CITY OF ALBUQUERQUE

**Re: Broadstone Promenade Phase 16
7400 San Pedro Dr. NE
Permanent CO – Accepted
Engineer's Stamp dated: 5-26-15 (D18D054A)
Certification dated: 4-25-16**

DRAINAGE CERTIFICATION

OVERALL  
GRADING AND DRAINAGE PLAN

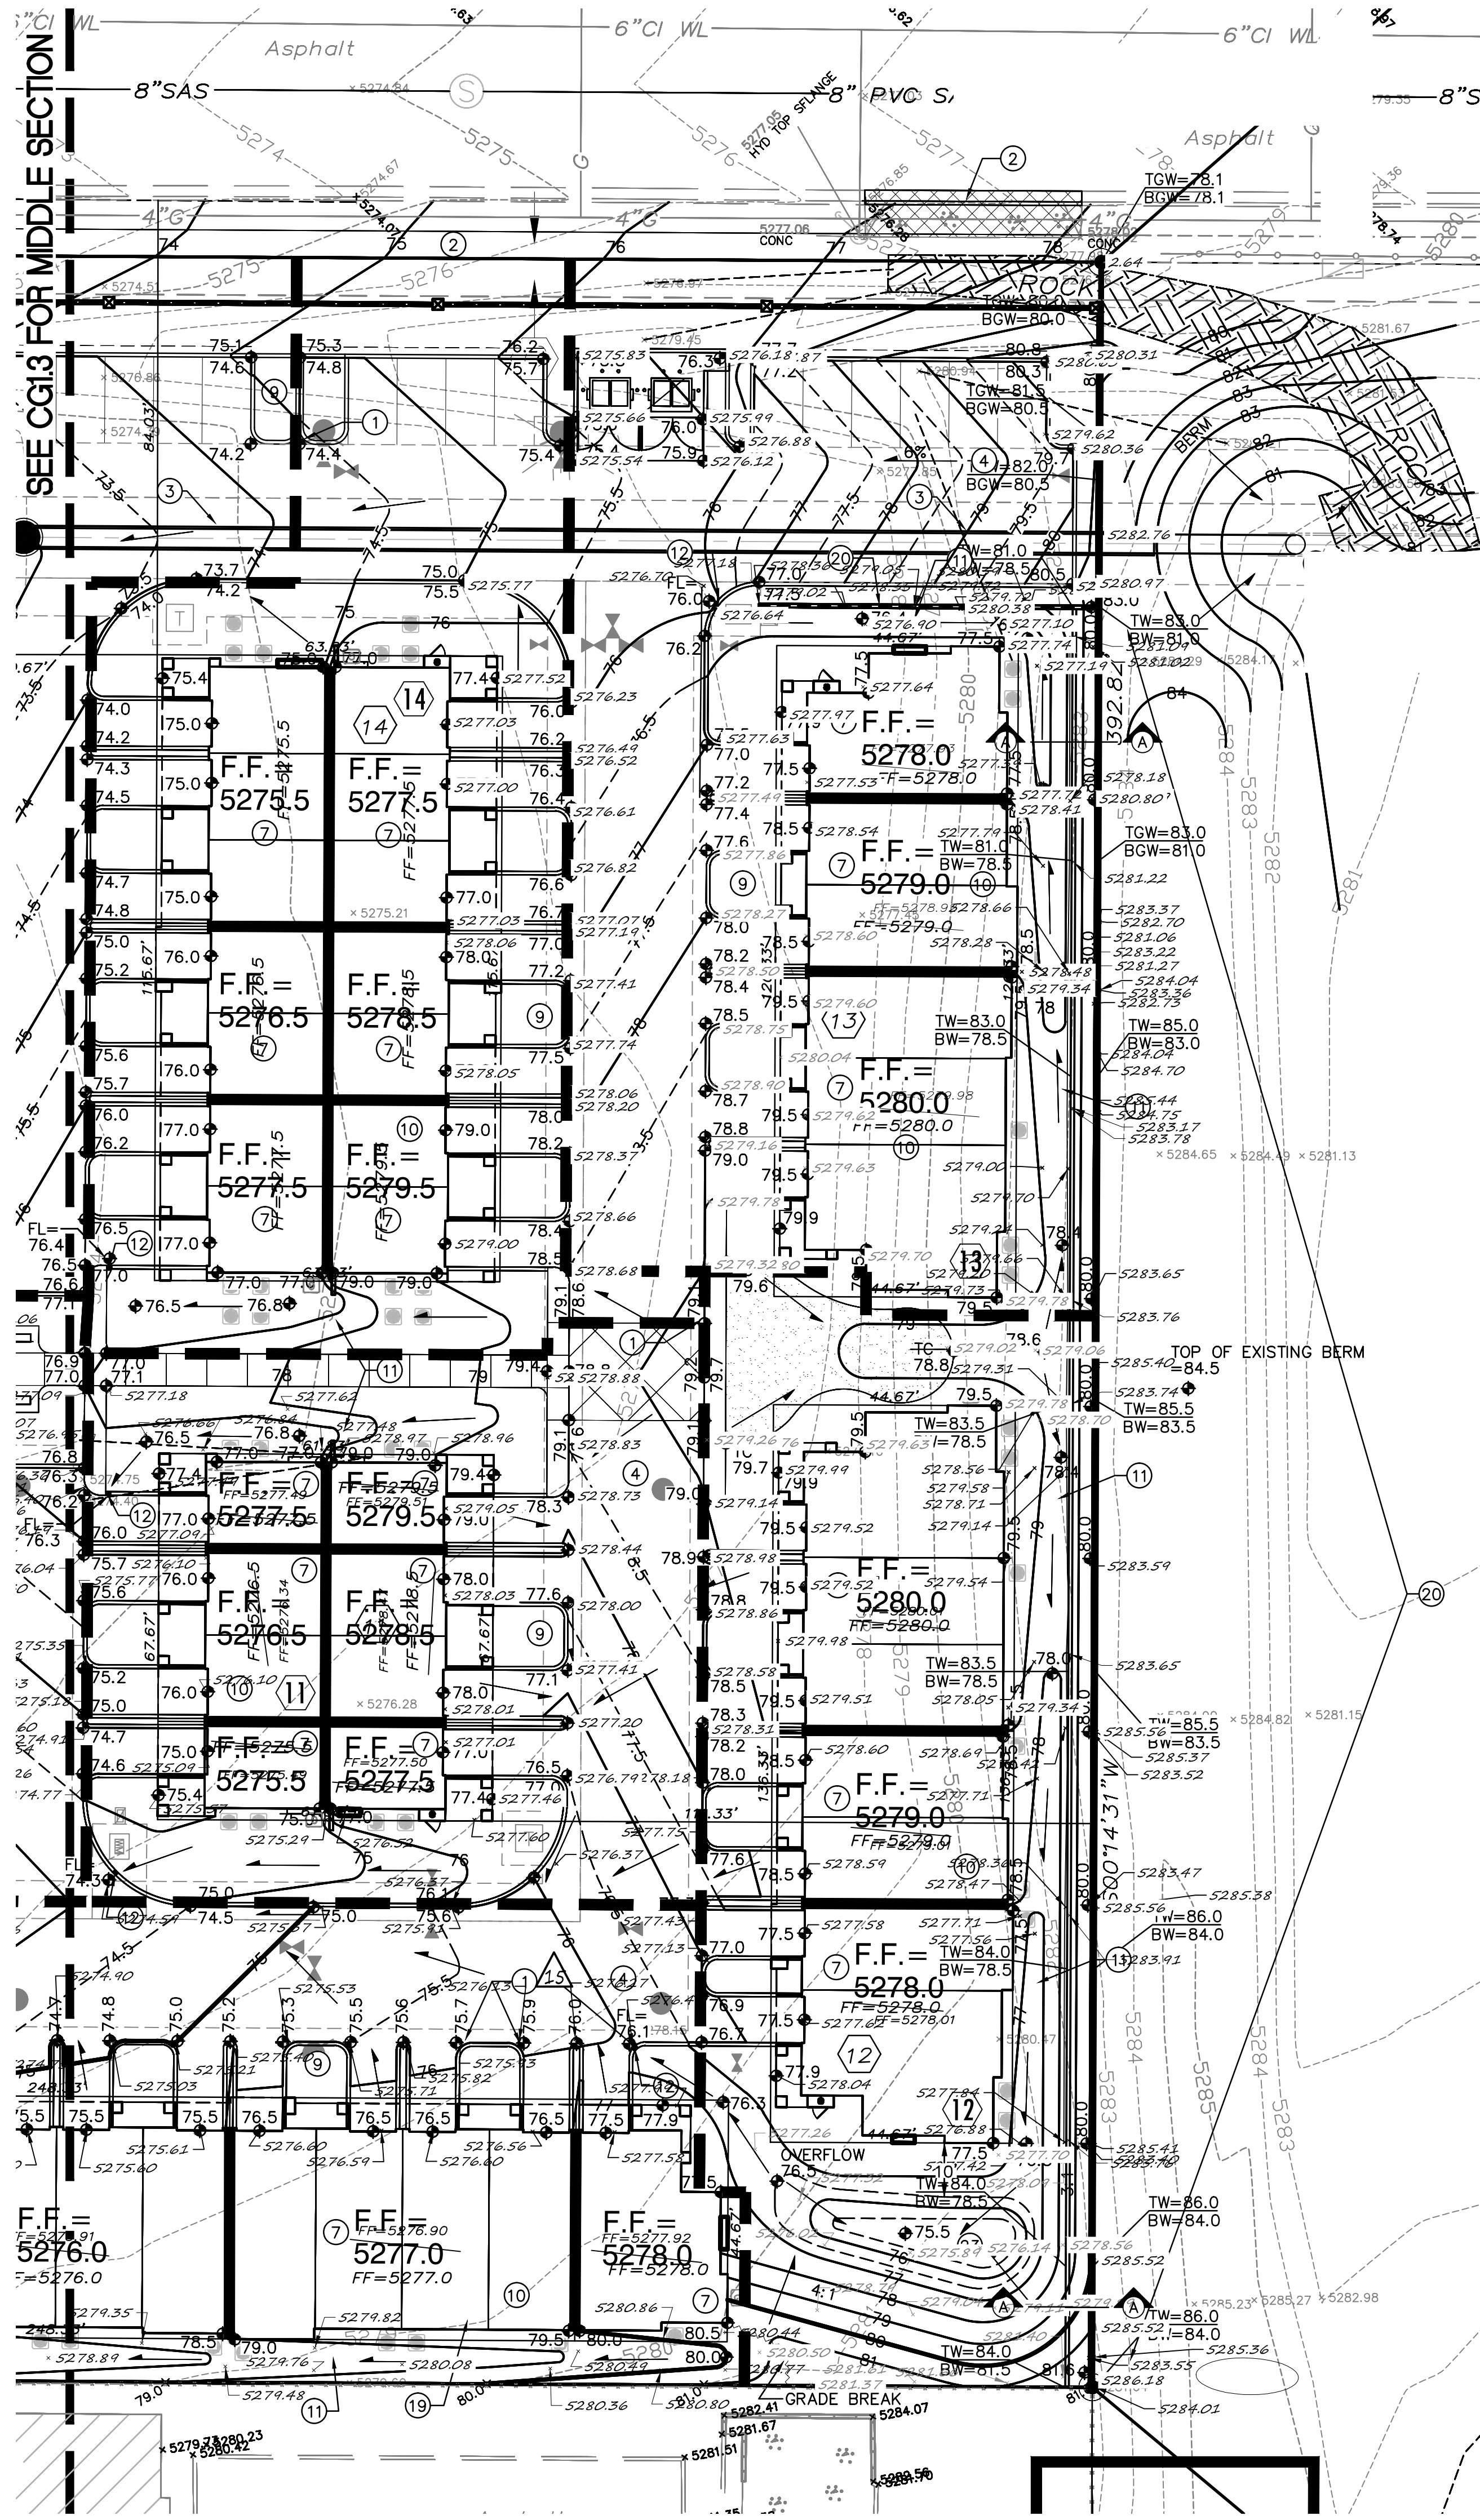
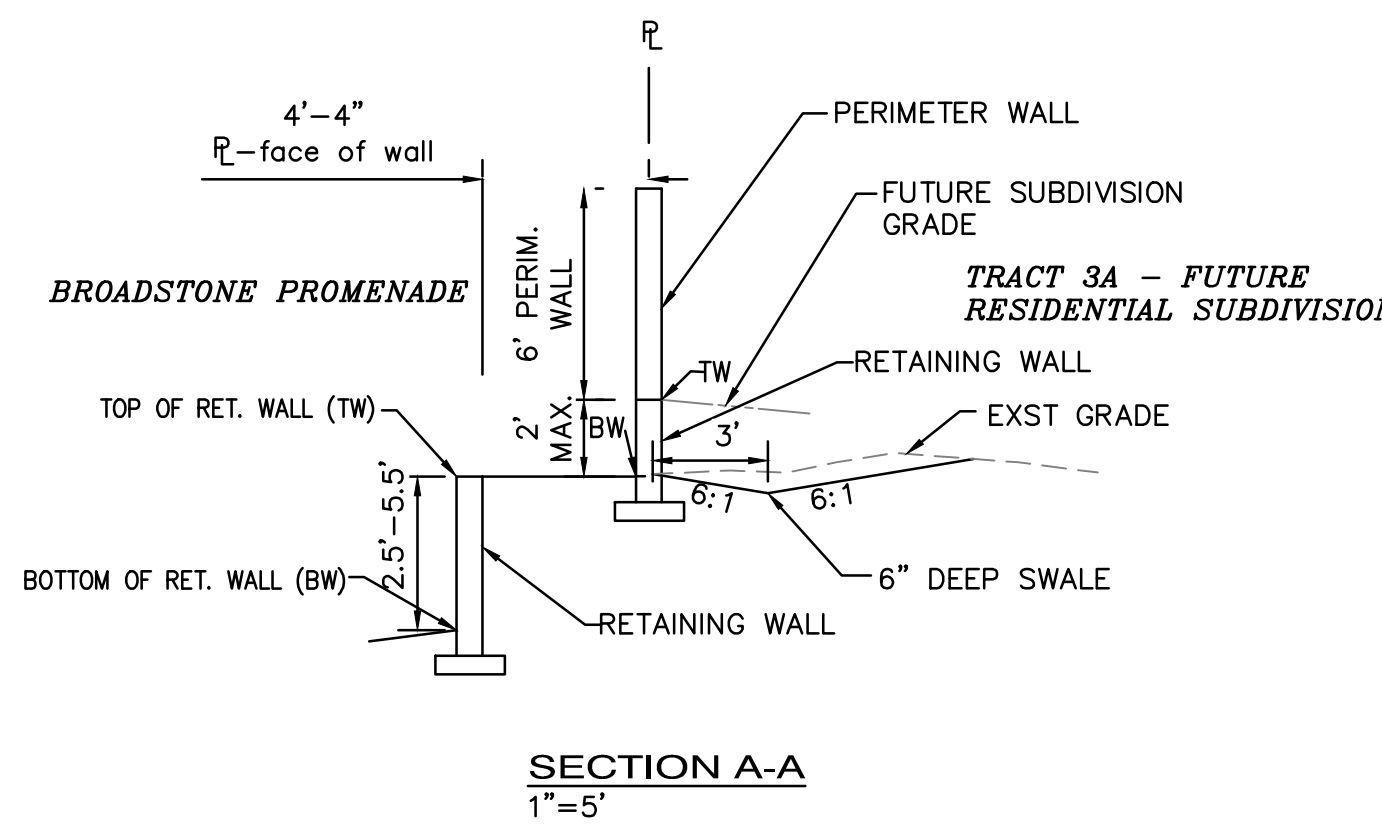
- △ SIDEWALK CULVERT NOT CONSTRUCTED. CULVERT SHALL BE CONSTRUCTED PRIOR TO CERTIFICATION OF BUILDING 2.

- △ LOWER/ADJUST STORM DRAIN GRATES TO GRADE, TO BE VERIFIED PRIOR TO CERTIFICATION OF PHASE 3.

- △ INSTALLATION OF SIDEWALK CULVERT OR PVC PIPES TO BE VERIFIED PRIOR TO CERTIFICATION OF PHASE 4.

- △ GRADING OF SLOPE TO BE VERIFIED PRIOR TO CERTIFICATION OF PHASE 4.

- △ COMPLETION OF ITEMS FROM PHASES 3 & 5 TO BE VERIFIED PRIOR TO FINAL CERTIFICATION.

- △ INSTALLATION OF 4" PVC PIPES TO BE VERIFIED PRIOR TO FINAL CERTIFICATION.

- △ LANDSCAPING TO BE ADJUSTED SUCH THAT A SWALE DIRECTS STORM WATER TO PIPES OR SIDEWALK CULVERTS AND THAT TOP OF MATERIAL IS AT INVERT OF PIPE OR CULVERT TO ALLOW FOR FLOW THROUGH. UNDER NO CIRCUMSTANCES SHOULD THE ENDS OF PIPES OR CULVERTS BE BURIED. THIS SHALL BE VERIFIED PRIOR TO FINAL CERTIFICATION.

- △ OBTAIN ADDITIONAL AS-BUILT SPOTS TO ALLOW FOR VERIFICATION OF DRAINAGE PATHS AND SLOPES PRIOR TO FINAL CERTIFICATION.

- △ GRADE A DEFINED SWALE/OVERFLOW PATH TO BOTTOM OF SIDEWALK CULVERT AND LINE SWALE WITH FRACTURED FACE ROCK. TOP OF ROCK ELEVATION SHALL BE AT INVERT OF CULVERT.

- △ LOWER INLET 0.5'.

- △ CONSTRUCTION OF ITEMS 8 & 9 SHALL BE COMPLETED BEFORE CERTIFICATION OF PHASE 7.

- △ 4" PIPES INSTALLED THROUGH SIDEWALKS.

- △ RIM ELEVATION OF INLET (ITEM 8) SHALL BE VERIFIED PRIOR TO FINAL CERTIFICATION.

- △ SIDEWALK CULVERT SHALL BE CONSTRUCTED PRIOR TO PHASE 10 CERTIFICATION.

- △ DRAIN PIPES SHALL BE INSTALLED PRIOR TO PHASE 10 CERTIFICATION.

- △ CHIPPED SIDEWALK CONCRETE AND DEFORMED DRAINAGE PIPES. DRAIN PIPES SHALL BE REINSTALLED PRIOR TO FINAL CERTIFICATION.

- △ SIDEWALK MODIFICATION AND SIDEWALK CULVERT RELOCATION.

- △ CURB OPENING NOT INSTALLED---NOT NEEDED AFTER THE SIDEWALK MODIFICATION AND SIDEWALK CULVERT RELOCATION.

- △ 2 DRAIN PIPES INSTALLED

- △ STEP NOT CONSTRUCTED

- △ 12" VALLEY GUTTER CONSTRUCTED
